TOWN OF IPSWICH OPEN SPACE COMMITTEE

MEMORANDUM

SUBJECT: 55 Waldingfield Road Great Estates Preservation Development

DATE: November 8, 2021

OSP-3: Pasture Areas (November 3, 2021)

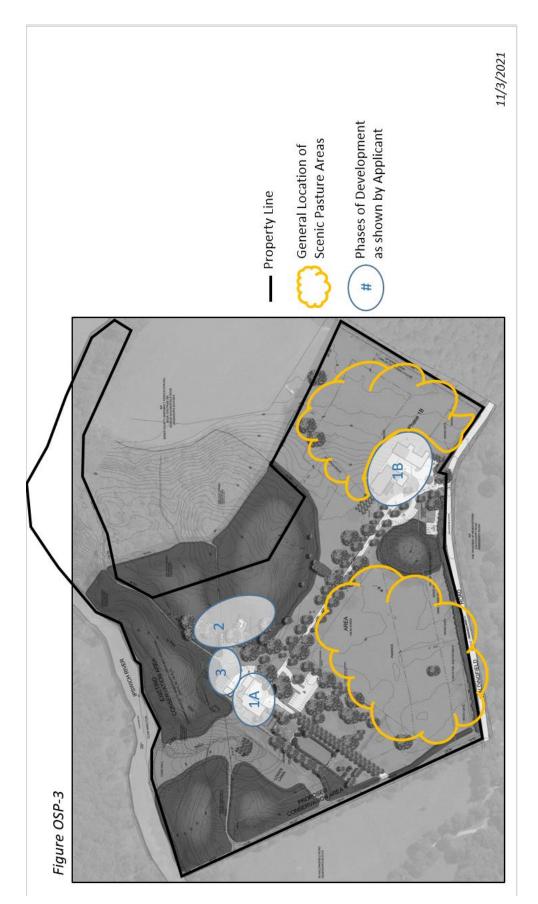
design and character of the existing estate (primary intent of bylaw), are the front two pastures. These pastures, highly visible from Waldingfield Road, are valuable as scenic vistas and active agricultural areas and should be the priority for open space protection. As such, those two pasture areas, in their entirety, should be permanently protected as open space (*see attached figure OSP-3*).

Based on our evaluation of the onsite features, we deem that the side and front setbacks (i.e. buffers from adjacent properties and the road as required by the GEPD Bylaw Section 5.d.i.), as proposed by the applicant, are <u>not</u> "the best possible use of the open space" and therefore should not be the priority areas set aside for open space protection.

As previously stated, permanent protection of this property's highest profile open spaces (i.e. the two pastures) is of the upmost importance. Protecting natural features and their aesthetic value for the long term is a foundational purpose of the GEPD bylaw. By not protecting an open space highly valued for its current condition it would leave those areas vulnerable to future development.
